EAST GRAND SCHOOL DISTRICT
Fraser Valley Elementary School
Renovation Summer 2026

1	03/05/2026	Addendum 01
No.	Date	Revision

Project Name
Fraser Valley Elementary School
Renovation Summer 2026

Project Number	
222000.50	
Date (YYYY/MM/DD)	
2026/02/11	
Drawn By	Checked By
GW	KA
Drawing	
GENERAL INFORMATION AND SHEET INDEX

E-121A

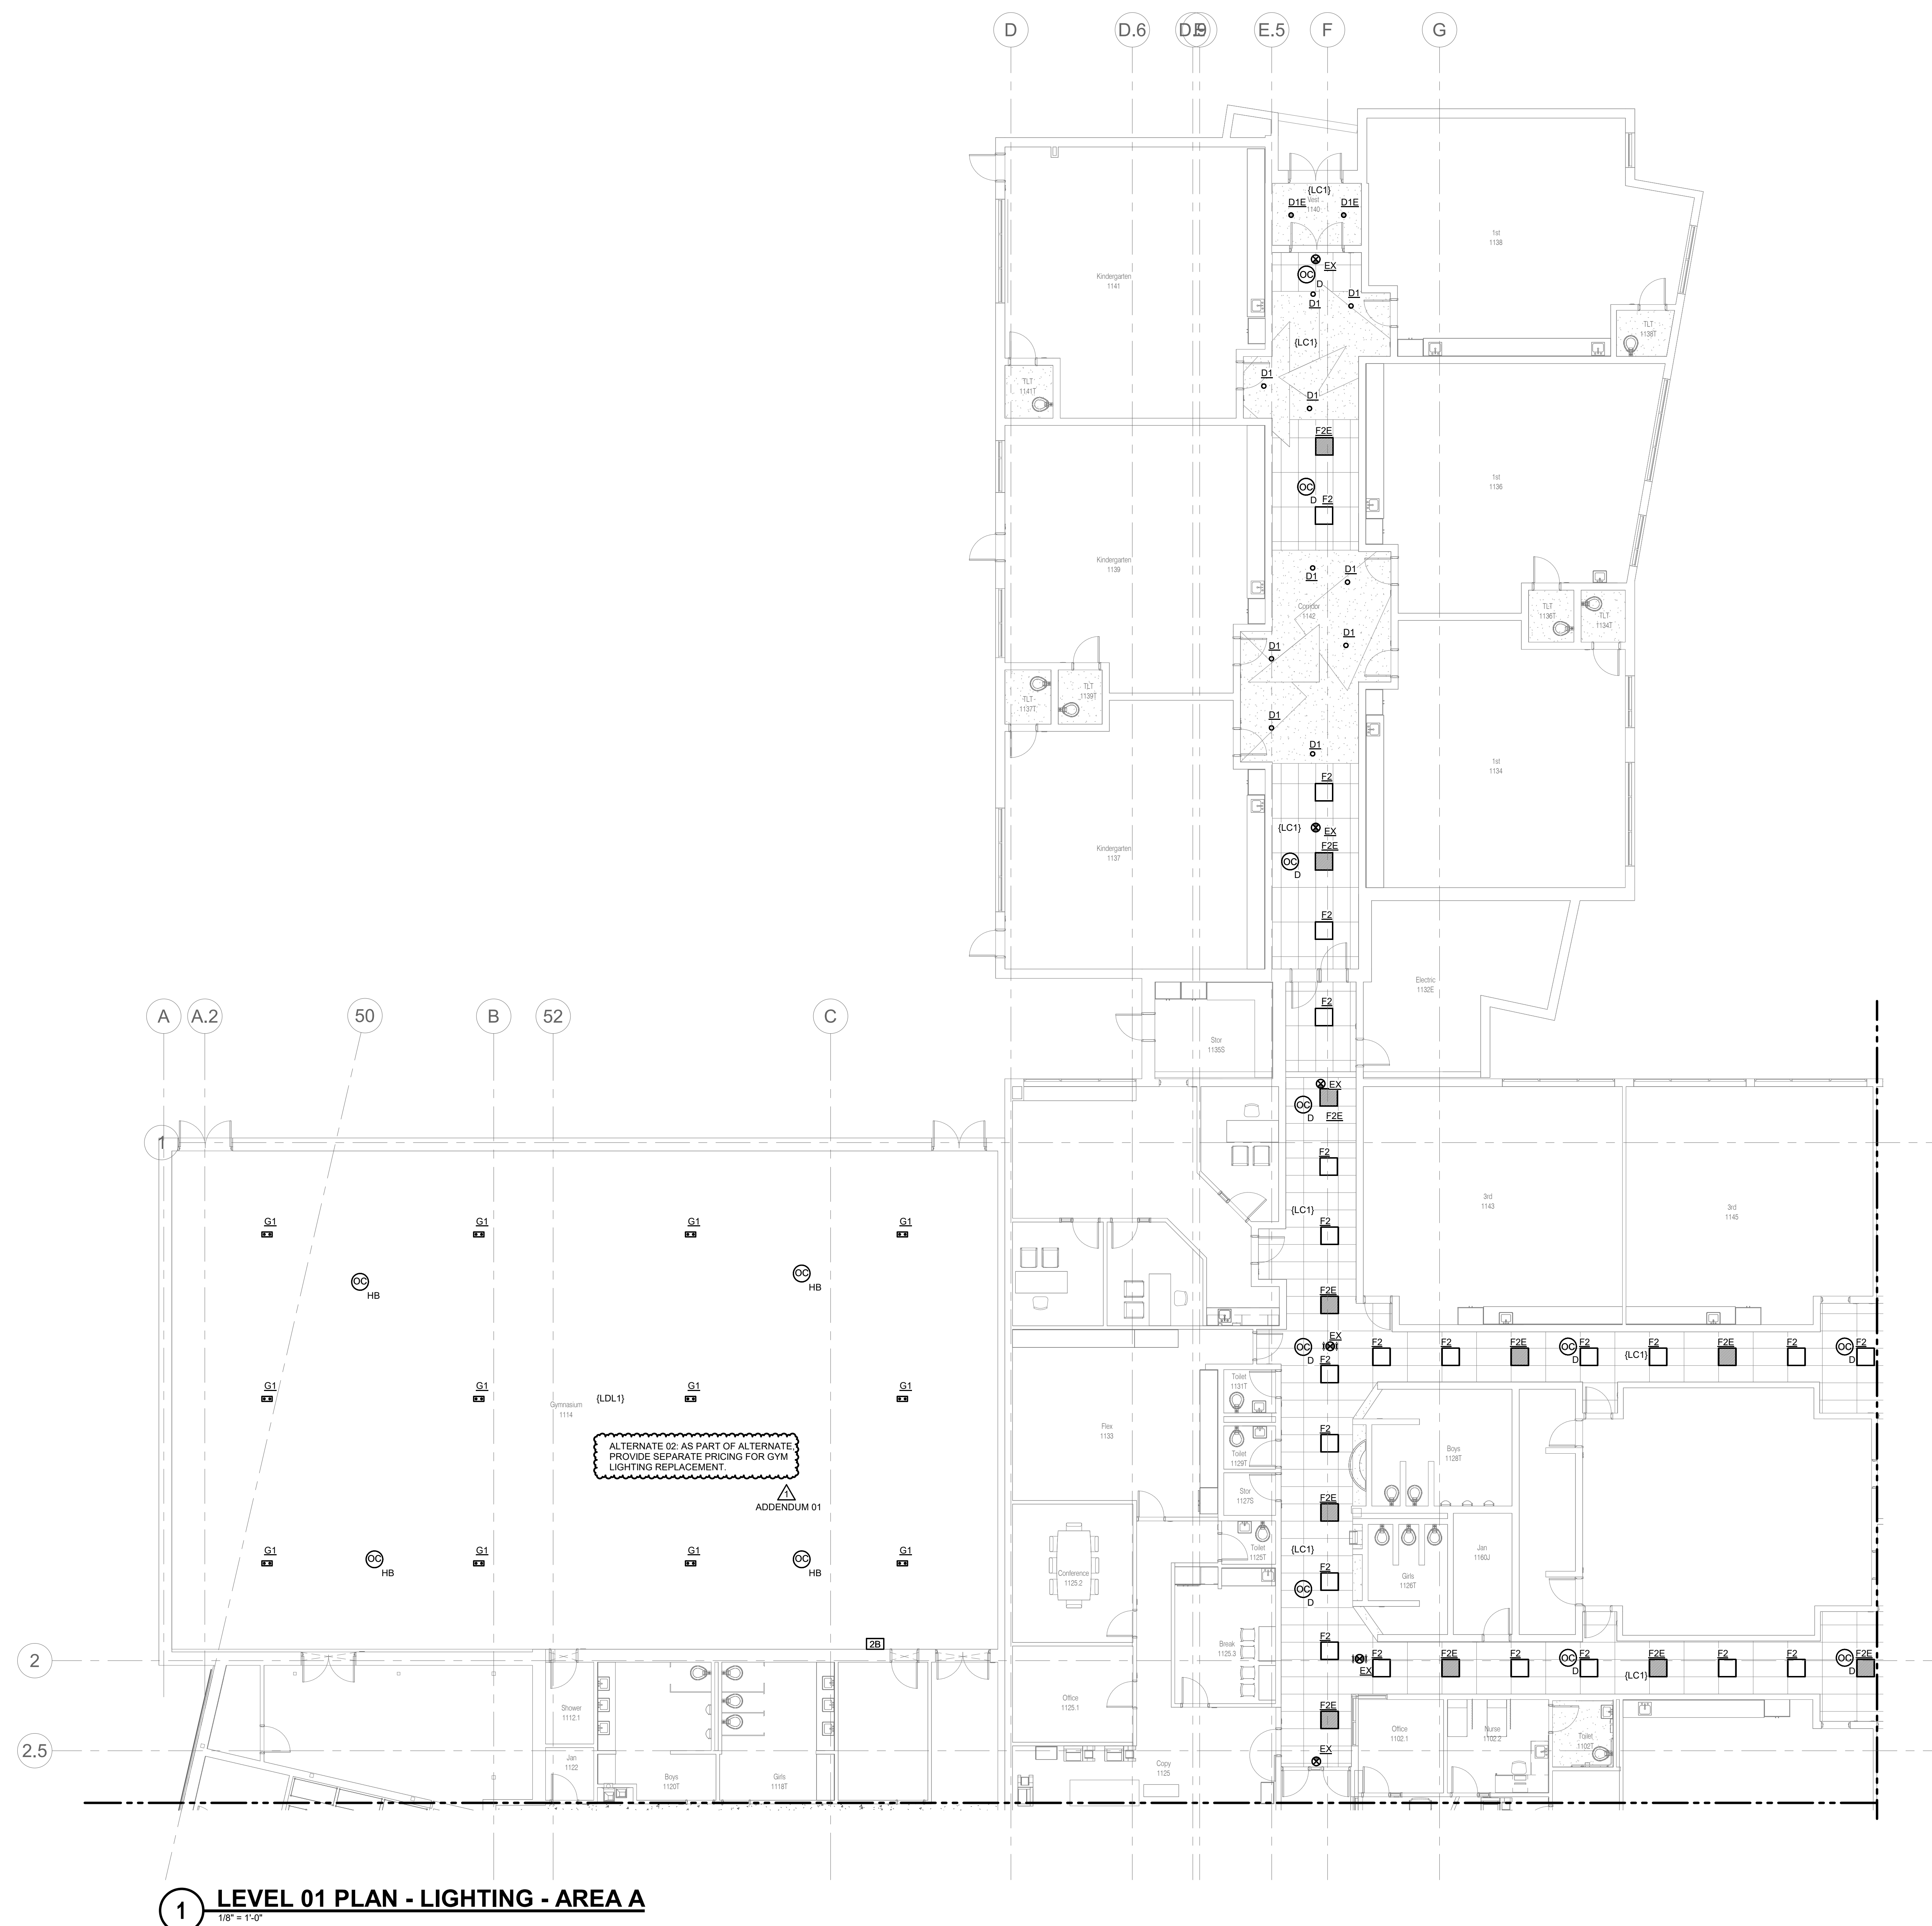
1. ALTERNATE 02: ALL LABOR AND MATERIALS RELATED TO LIGHTING REPLACEMENT SHALL BE SEPARATED AS AN ALTERNATE SCOPE OF WORK. PROVIDE SEPARATE PRICING FOR SCHOOL DISTRICT REVIEW.
2. EC TO WIRE NEW LIGHTING AND LIGHTING CONTROL DEVICES TO EXISTING SAVED CIRCUITS. LOAD ADDED IS LESS THAN LOAD REMOVED. PROVIDE MULTI-VOLT DRIVERS FOR ALL FIXTURE TYPES, AND FIELD VERIFY CIRCUIT CHARACTERISTICS PRIOR TO START OF WORK.
3. ALL EXIT SIGNS TO BE CIRCUITED AHEAD OF LOCAL CONTROLS.
